Integra Apparel (Bangladesh) Co., Ltd.(11376)

ACCORD
on Fire and Building Safety in Bangladesh

Site Observations

Proposed 4 Storey Structural Drawing

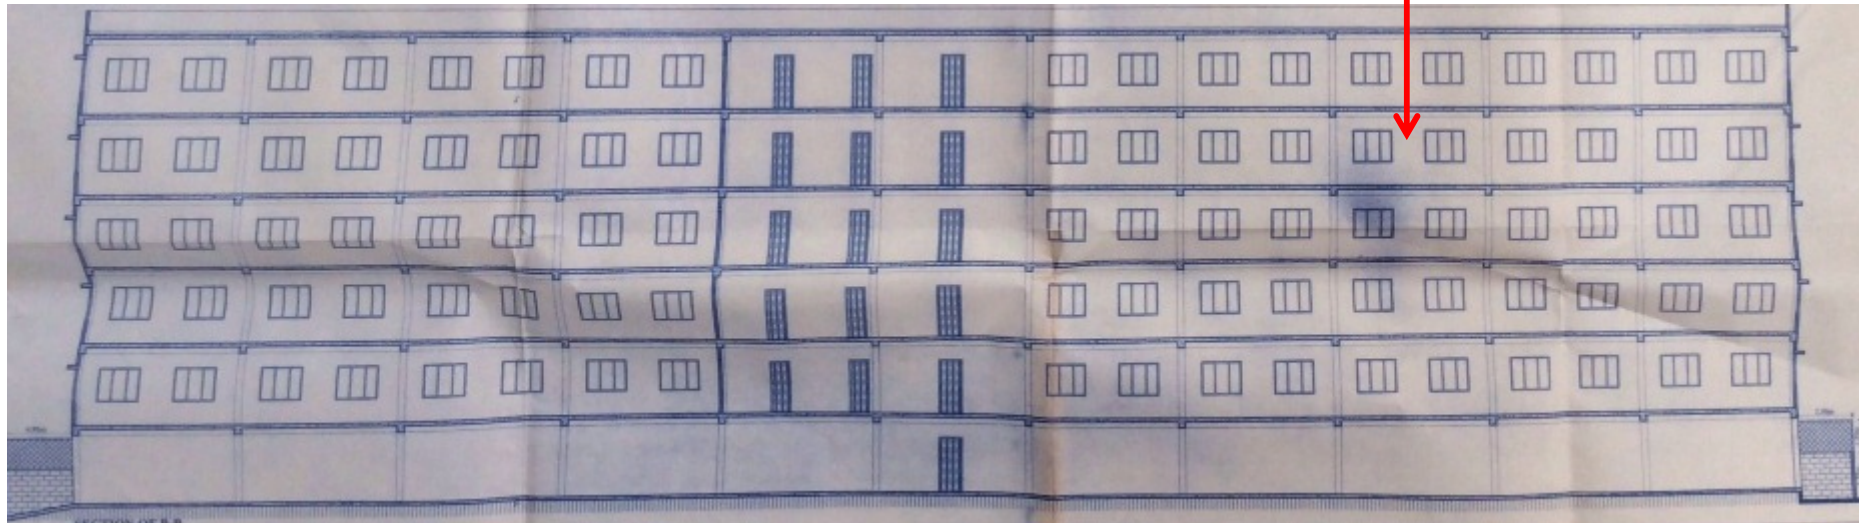
Adequacy of column and foundation capacities are required to be investigated and confirmed.

Load rundown based on the 4 storey structural drawings - at a key steel column, it is found that the steel column has a FOS between 1.25 and 1.50 which gives an AMBER rating.

Load rundown based on the 6 storey architectural drawings - at a key steel column, it is found that the steel column has a FOS lower than 1.00 which is RED rating.

NOTE: The structural drawings don't match with the architectural drawings. The adequacy of the columns and foundations must be investigated and confirmed.

- A Detailed Engineering Assessment of factory to be carried out and in particular column capacity and foundation aspects to be investigated in detail.

- Continue to implement loading plan. Detail engineering assessment to be completed.
- Do not construct any further structural construction without a thorough structural design and full building approval.

Capacity check for fire escape steel staircase

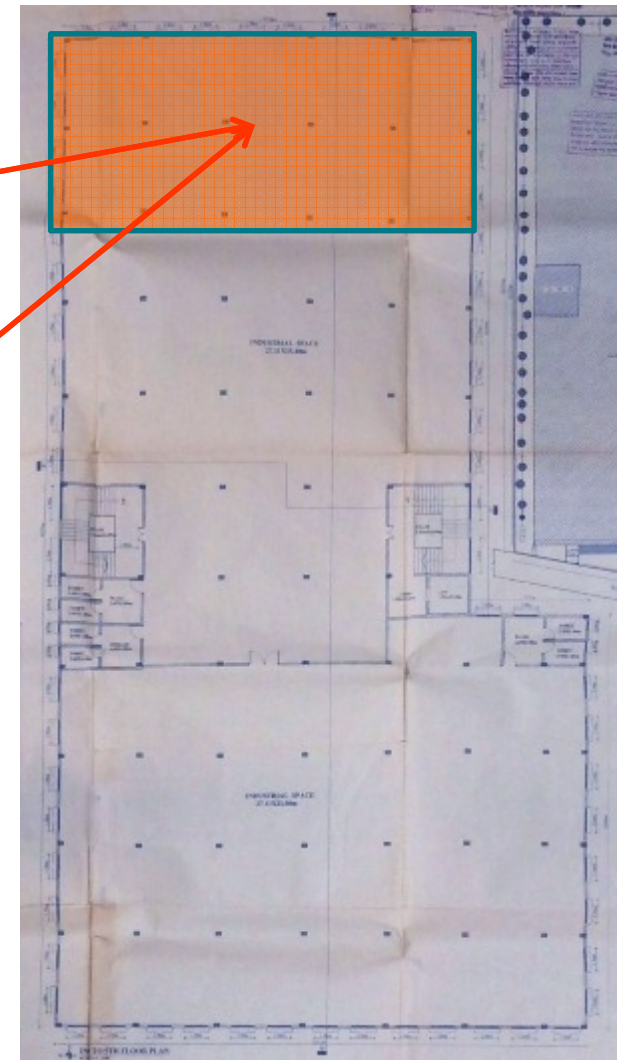
Capacity check for fire escape steel staircase is required due to no drawings being provided.

- A Detailed Engineering Assessment to be carried out in particular the steel column capacities and the connection capacities.

- Continue to implement loading plan. Detailed Engineering Assessment is to be completed.

Overall Stability System

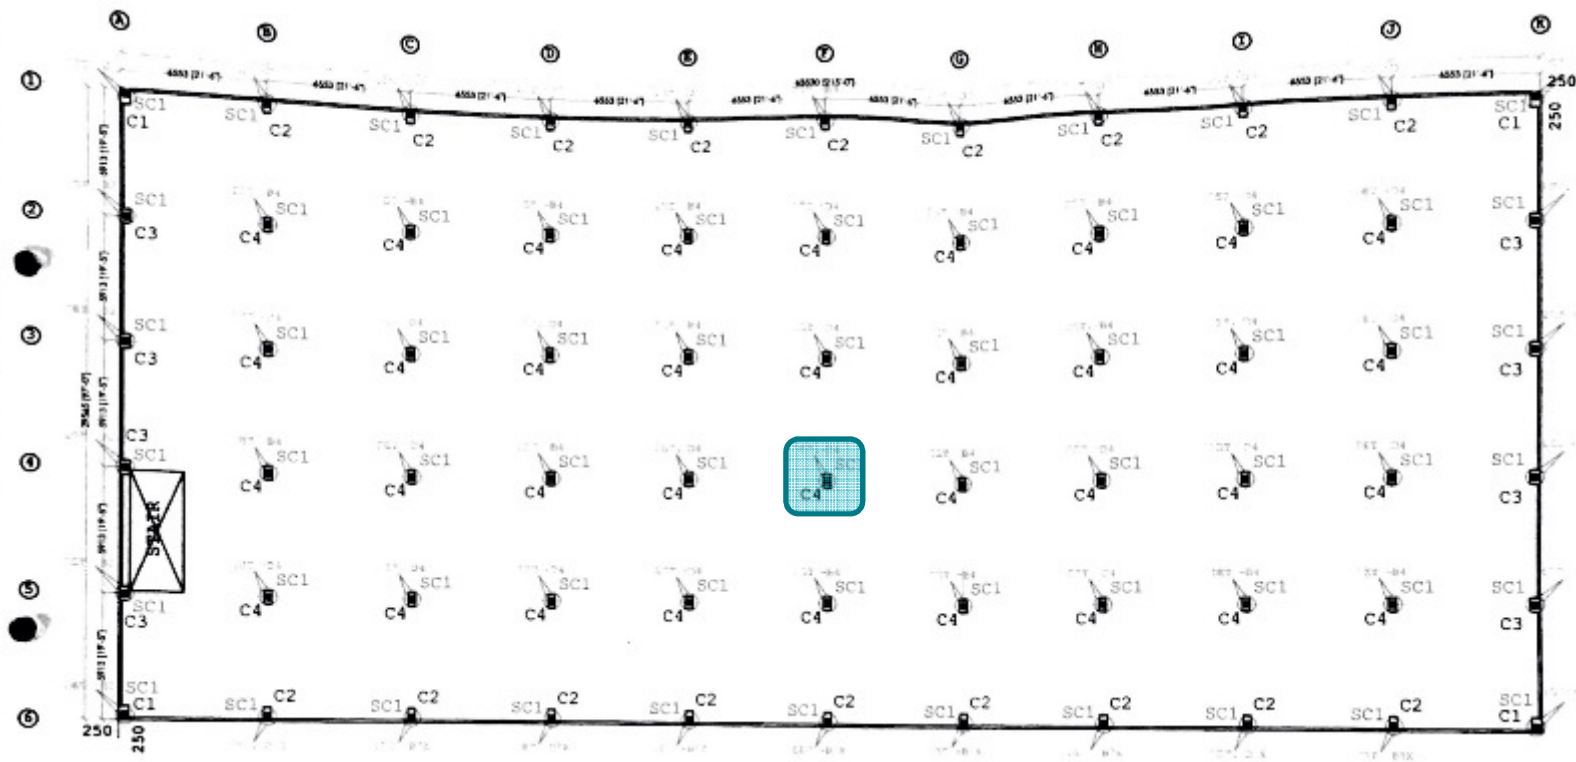
Further detail engineering assessment is required whether such system can resist the lateral load from wind & earthquake

Concerns on the stability system for lateral loading and seismic loading. Façade brickwork with little capacity; lack of moment capacity in connection between columns and beams.

- Detail engineering assessment to be carried out in particular stability and foundation aspects to be investigated in detail.
